APPENDIX B

Summary of DRA Analysis of Late-Filed ALJ Exhibit

A. Estimation of hydrotest costs used to calculate disallowances for pipe replacement projects

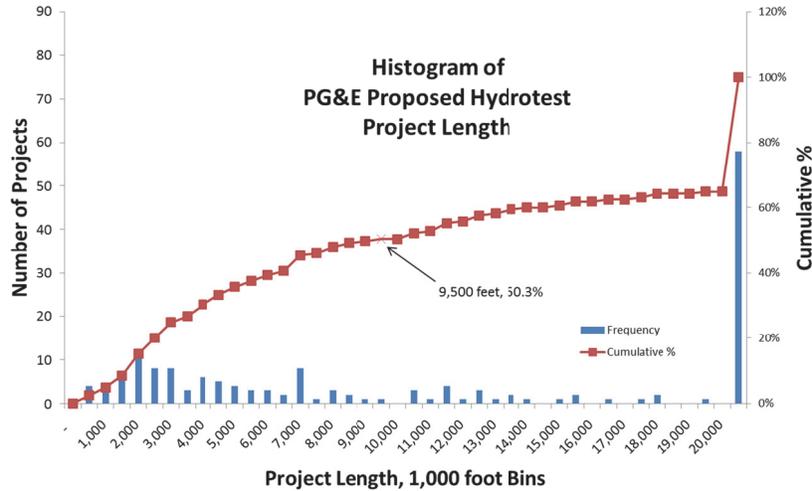
In addition, the record shows that hydrotest costs per foot decrease with increased length of a project, as fixed costs are spread over a larger length of pipe. The following chart shows hydrotest costs per foot for PG&E’s 165 proposed hydrotests projects, as a function of the length of each project:⁹

This chart shows that short test projects, including all those shorter than 10,000 feet, have a cost per foot higher than \$95.8.

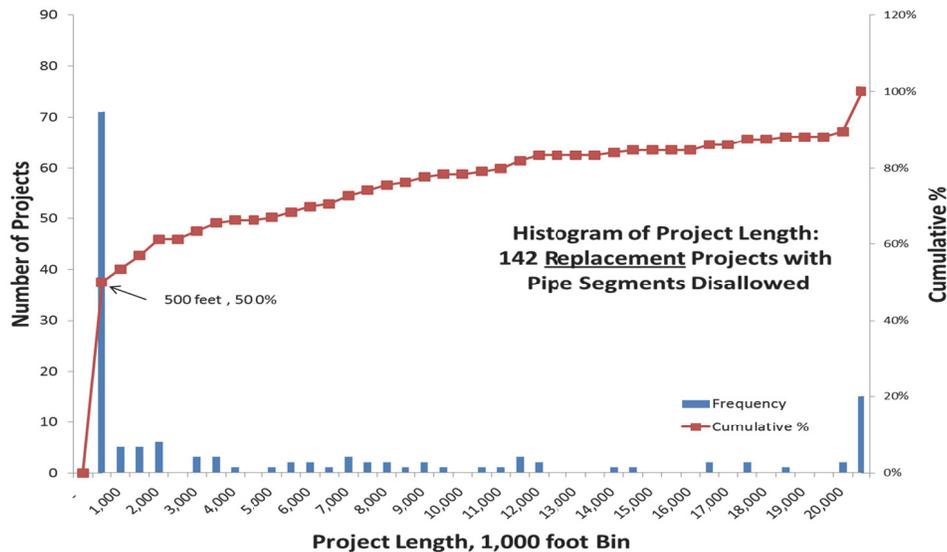
In comparison, the median length of PG&E’s proposed *replacement* projects is 509 feet, over 17 times less than the median length of *hydrotest* projects:¹²

This chart shows that the majority of proposed *replacement* tests (84 of 168) are less than 1,000 feet long.

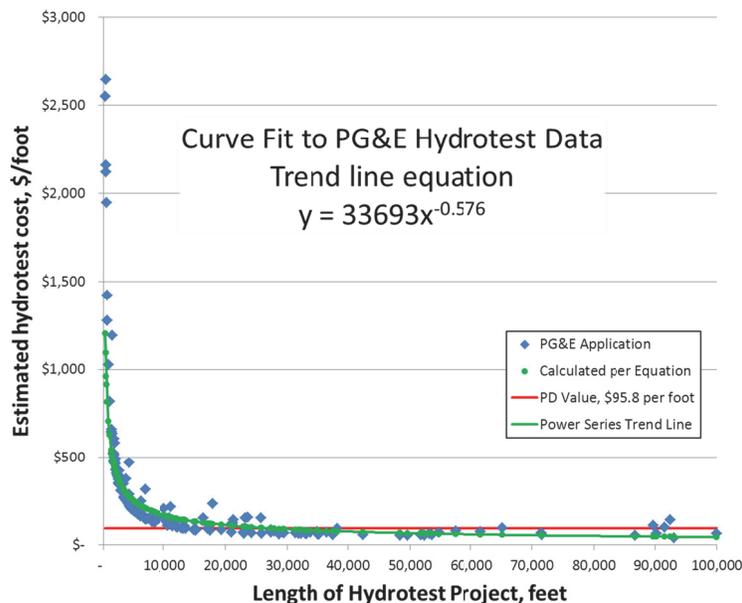
Not all replacement projects have segments that are disallowed, regardless of whether PG&E or DRA’s cost allocation criteria are used. DRA therefore performed a similar analysis on the 142 replacement projects with disallowances using the criteria of Scenario 3 as described in Section II.A.2(a) of DRA’s Comments on the PD.¹³ The median value of these projects, 512 feet, and the frequency distribution are similar to the full set of replacement projects:¹⁴

This data shows that PG&E pipe *replacement* projects are much shorter than *hydrotest* projects, and that the single estimated hydrotest cost of \$95.8 per foot is inappropriately low for use for replacement projects, the majority of which have short pipe lengths.
